LOS ANGELES UNION STATION FORECOURT AND ESPLANADE IMPROVEMENTS PROJECT

ADDENDUM NO. 1 TO THE ENVIRONMENTAL IMPACT REPORT

JULY 2, 2018

Figure 4.2-1. LAUS Phase 1 Investigations Exhibit

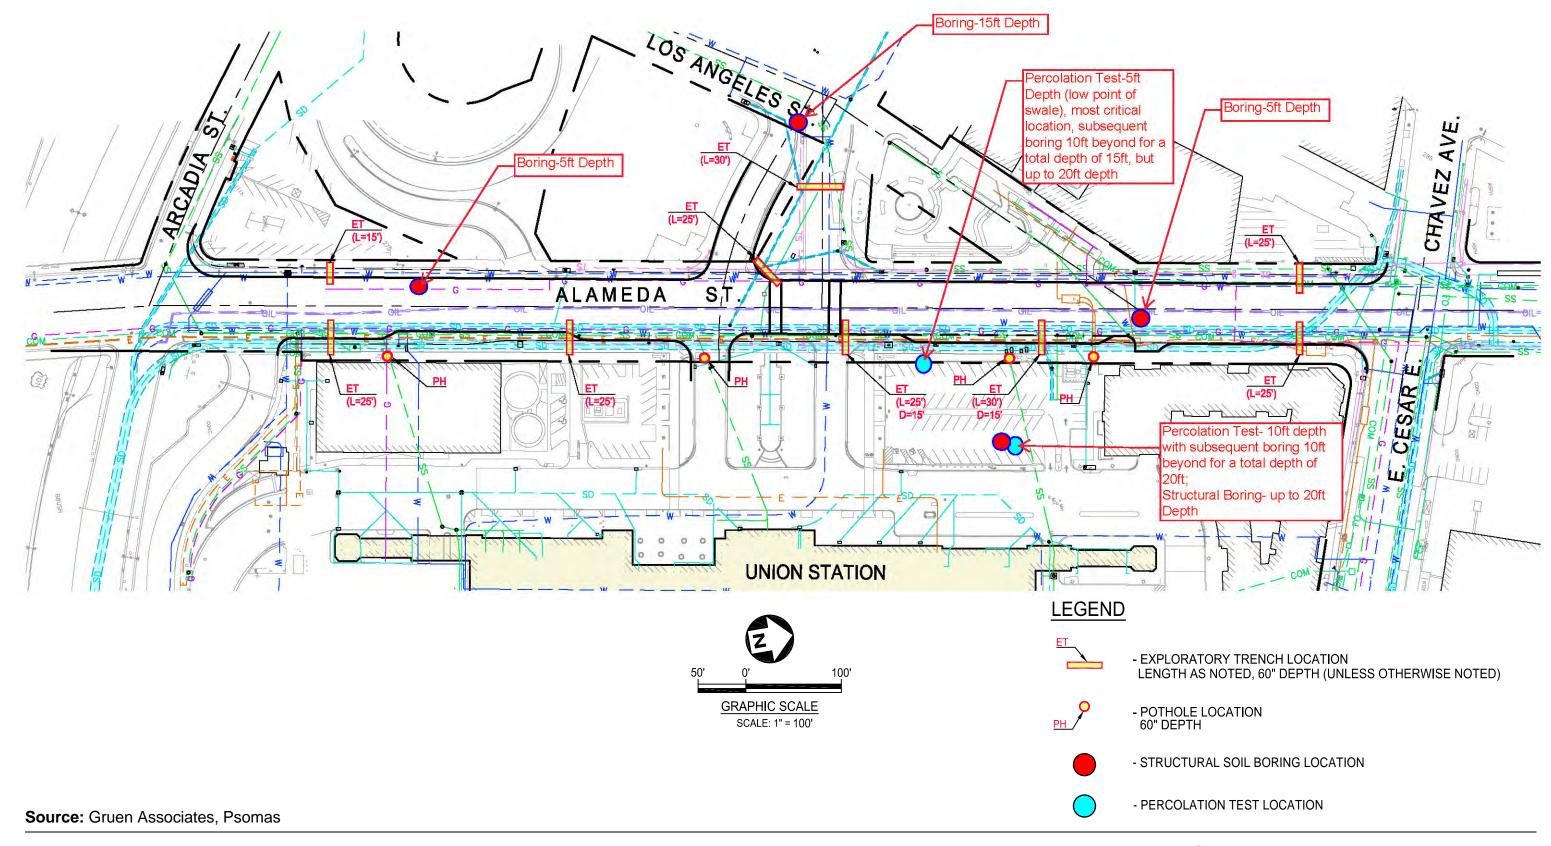
Investigations will be undertaken in two phases: (1) geotechnical, utility and cultural resources investigations to be undertaken by to inform the project design (Figure 4.2-1); and (2) utility and supplemental cultural resources investigations to be undertaken by a construction contractor, asneeded to inform construction (Figure 4.2-2).

The 1st phase of the investigations will include percolation tests, borings, potholing, exploratory trenching, and archaeological shovel test pits. Some of the testing will encroach on public sidewalks and roadways, thus requiring preparation and implementation of a Traffic Control Plan. The exact traffic requirements will be determined by a traffic engineer, and plans shall be submitted and approved by the City of Los Angeles Department of Transportation (LADOT) prior to the start of the investigations. Percolation tests will be undertaken at the proposed LAUS Forecourt (Figure 4.2-1). The purpose of the percolation tests is to provide information regarding the soil stability, porosity, and drainage properties at the site. The percolation tests will follow the standard methodology is American Society for Testing and Materials (ASTM) D3385, which involves a double ring infiltrometer for percolation in soils. The specific method to be used will be confirmed with the contractor. Percolation tests will be up to 10 feet in depth, with a subsequent boring up to 20 feet, and take an average of 4 hours per test. Percolation tests up to 5 feet in depth will require hand auger equipment and two light duty trucks for support (Table 4.2-1). For tests beyond 5 feet, a standard truck-mounted hollow stem auger drill rig would be used instead of the hand auger equipment. In addition to the subsequent boring accompanying the percolation test undertaken on the LAUS site, up to four additional structural borings will be undertaken on Alameda Street and Los Angeles Street (Figure 4.2-1). The purpose of the borings is to provide information regarding the soil structure including the soil composition, soil bearing pressure, and location of the groundwater table. Similar to the percolation tests, the borings will use the standard truck-mounted hollow stem auger drill rig and two light duty trucks for support. Borings will range from 5 to 20 feet in depth and take an average of 4 hours per boring.

The purpose of the potholes and trenches is to provide information regarding underground utilities for possible relocation or avoidance. Potholing will be done with vacuum excavation and completed in accordance with the latest adopted edition and supplements of The Standard Specifications for Public Works Construction and the latest revision of The Brown Book. Both potholing and trenching will require heavy construction equipment which may include, but is not limited to, a vacuum extraction truck, concrete saw, concrete trucks, dump trucks, skid steer, asphalt paving machine, road roller, asphalt tamper, jack hammer, trench box, and two light duty worker trucks. Potholes and trenches will range from 5 to 15 feet in depth. Trenches range from 15 to 30 feet in length. A few trenches may be excavated in layers to inform the evaluation of archaeological resources.

This Addendum to the EIR extends the maximum depth of excavation to up to 20 feet bgs, which is 5 additional feet beyond the 15 feet bgs analyzed in the certified EIR. For the geotechnical and utility investigations, the additional 5 feet is necessary because the percolation tests may need to go to 10 feet bgs in order to inform design. Associated borings will need to be 10 feet deeper than the percolation tests, thereby requiring a final depth of 20 feet bgs. The increase in depth of excavation will provide enough data to properly assess the overall vertical soil profile.

Figure 4.2-2. LAUS Phase 2 Conceptual Potholing and Trenching Exhibit

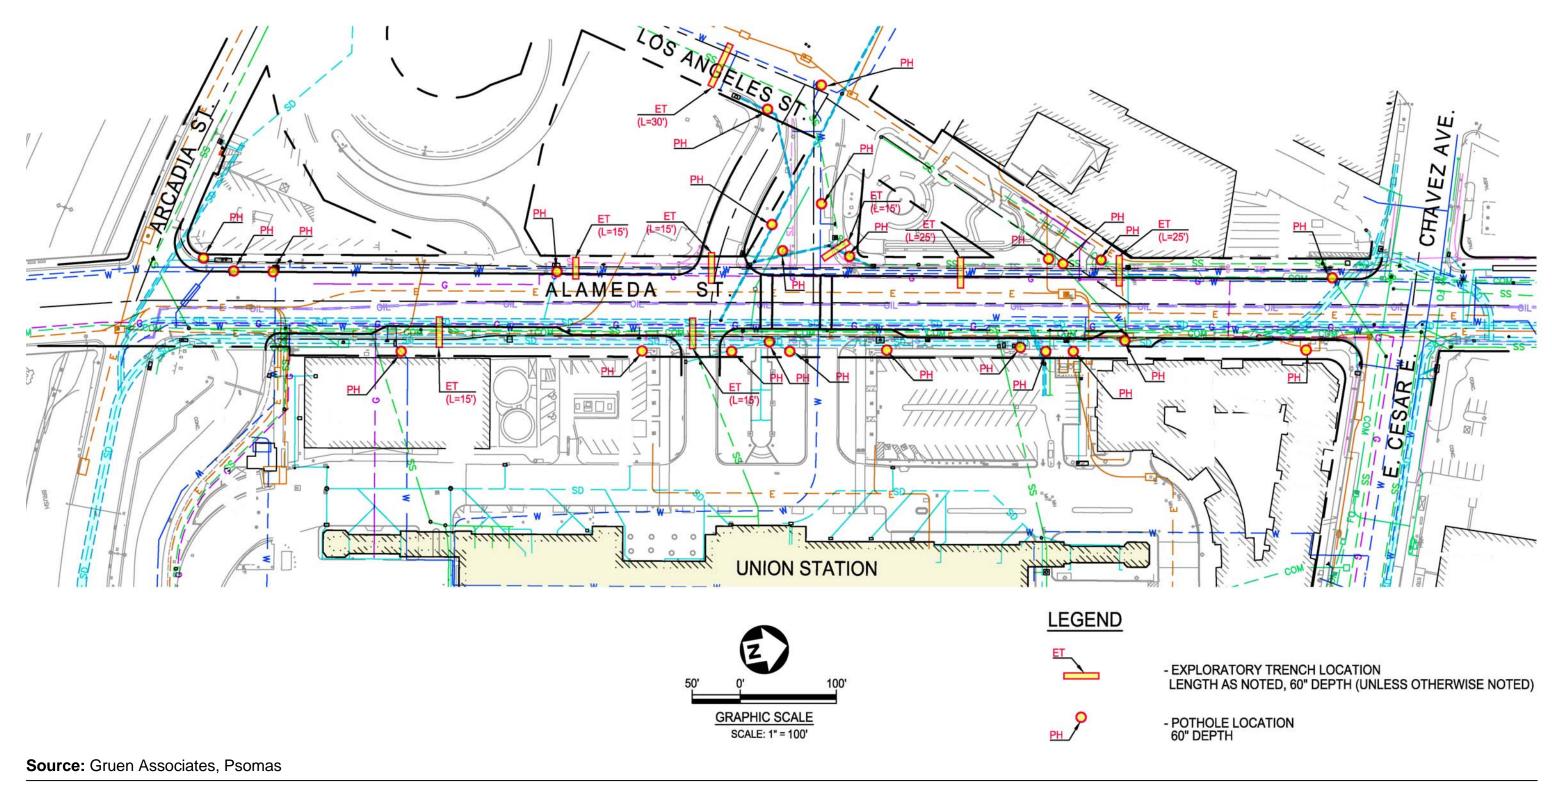
In addition to the investigations undertaken to inform the project design, it is anticipated that the construction contractor will undertake a 2nd phase of the investigations that will include additional potholing, trenching, and potentially archaeological shovel test pits. The exact location of such investigations will be at the discretion of the construction contractor; however, for the purpose of the analysis in this Addendum, the architecture and engineering design team developed a conceptual plan for 2nd phase investigations based on their experience with comparable projects (Figure 4.2-2). Some of the testing will encroach on public sidewalks and roadways, thus requiring preparation and implementation of a Traffic Control Plan. The exact traffic requirements will be determined by a traffic engineer, and plans shall be submitted and approved by the LADOT prior to potholing operation. It is anticipated that the contractor will conduct up to 25 potholes and 8 trenches at multiple locations in the proposed LAUS Forecourt, Alameda Street, and Los Angeles Street (Figure 4.2-2). These locations will be informed by prior investigations conducted in Phase 1. The purpose of the potholes and trenches is to provide information regarding underground utilities for possible relocation or avoidance. Potholing will be done with vacuum excavation and completed in accordance with the latest adopted edition and supplements of The Standard Specifications for Public Works Construction and the latest revision of The Brown Book. Both potholing and trenching will require heavy construction equipment, which may include, but is not limited to, a vacuum extraction truck, concrete saw, concrete trucks, dump trucks, skid steer, asphalt paving machine, road roller, asphalt tamper, jack hammer, trench box, and two light duty worker trucks. Potholing and trenching may occur concurrently within a 30-day time frame. Potholes and trenches will range from 5 to 15 feet in depth. Trenches range from 15 to 30 feet in length.

The vicinity of LAUS is an area with a known sensitivity to contain cultural resources as evaluated in the EIR; therefore, the contractor will likely undertake additional shovel test pits to characterize the vertical and horizontal extent of archaeological resources in construction work area program in conjunction with the 2nd phase of investigations (Figure 4.2-2). Up to 20 shovel test pits will be excavated to a depth of 2 to 4 feet using hand shovels and screens, should the utility assessments occur in areas that were not previously studied via test pits in Phase 1. The results of the shovel testing will the location and depth of archaeological deposits within the project area and will be used in the avoidance of significant archaeological resources through project design.
